February 19, 2020
Updated March 10, 2020

Responses to Comments from SCAQMD, Attorney General, CDFW and Blum Collins LP Letters on
Latitude Business Park Mitigated Negative Declaration

Table 1: SCAB 24-Hour Average Concentration CO Trend

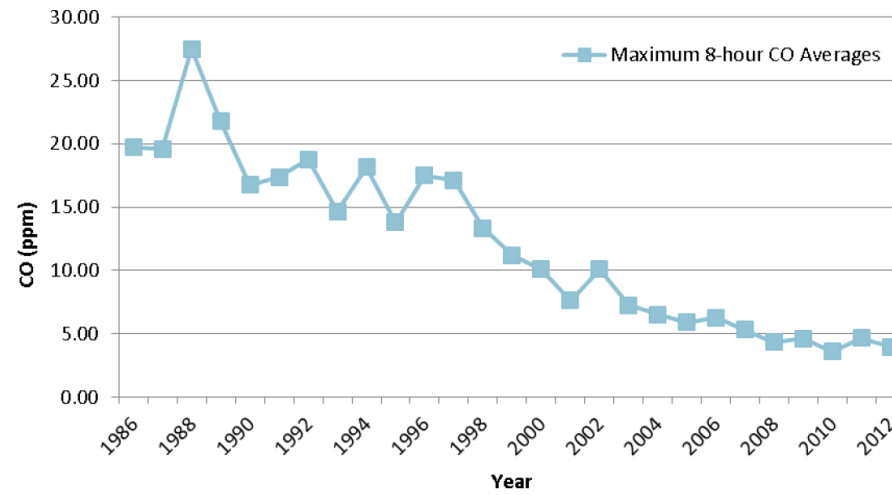
Comment	Response
<p>1.</p> <p>Localized Significance Thresholds (LST) Analysis for CO and PM2.5: The Lead Agency performed air dispersion modeling to analyze the Proposed Project's localized construction air quality impacts for NOx and PM10 and compared those with the most stringent air quality standards to determine the level of significance¹³. However, the Lead Agency did not analyze the localized air quality impacts for CO or PM2.5 in the MND. South Coast AQMD staff recommended that the Lead Agency analyze the Proposed Project's localized air quality impacts from construction activities for CO and PM2.5 and compare those emissions to the most stringer air quality standards, or provide reasons.</p>	<p>1.</p> <p>PM 10 and PM 2.5 have a threshold of 10.4 µg/m³. The project emissions for PM 10 were found to generate emissions less than 10.4 µg/m³. Given that project PM 10 emission are higher than project PM 2.5 emission, the LST impacts from PM 2.5 would also be less than 10.4 µg/m³. LSTs for CO were not calculated because ambient air quality data for CO is no longer monitored within the County of Riverside or at least the data isn't readily available.</p> <p>CO concentrations in the SCAB have decreased markedly — a total decrease of more about 80 percent in the peak 8-hour concentration since 1986 (See Table 1 on page 7). It should be noted 2012 is the most recent year where 8-hour CO averages and related statistics are available in the SCAB. The number of exceedance days has also declined. The entire SCAB is now designated as attainment for both the state and national CO standards. Ongoing reductions from motor vehicle control programs should continue the downward trend in ambient CO concentrations.</p>
